Technical Service Bulletin: TSB200223

Released Date: 28-Mar-2022

New Intercooler Transfer Tube Connection

Figure 1, New Water Transfer Tube Versus Existing Water Transfer Tube

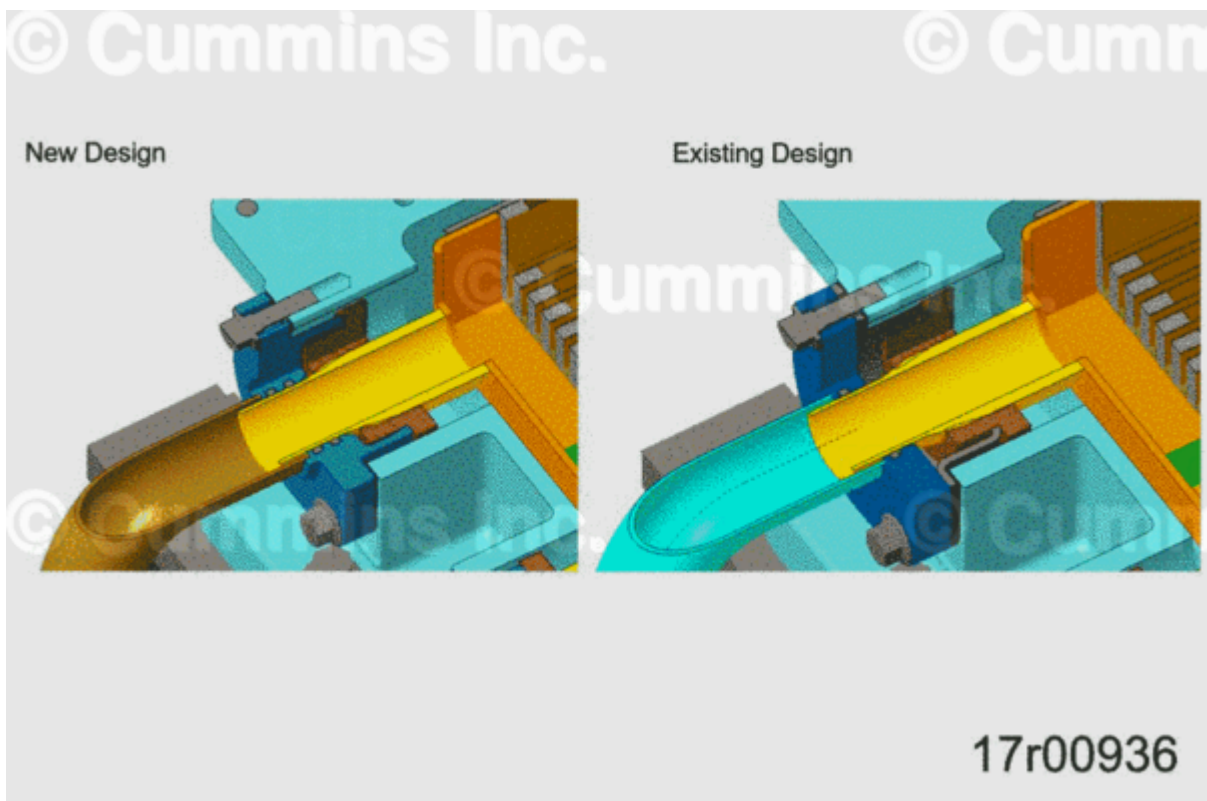
This TSB is to announce the new intercooler transfer tube connection with a Double O ring flange design. The new design includes the addition of a second O ring and an all in one water and air seal grommet. The Double O ring flange will hold the air seal.

The changes made to the flange design aim to improve contact area and sealing capability of the joint.

Use of P80 lubrication, Part Number 3824878, during O ring installation is recommended for ease of assembly.

Use existing part number inventory before using the new part number.
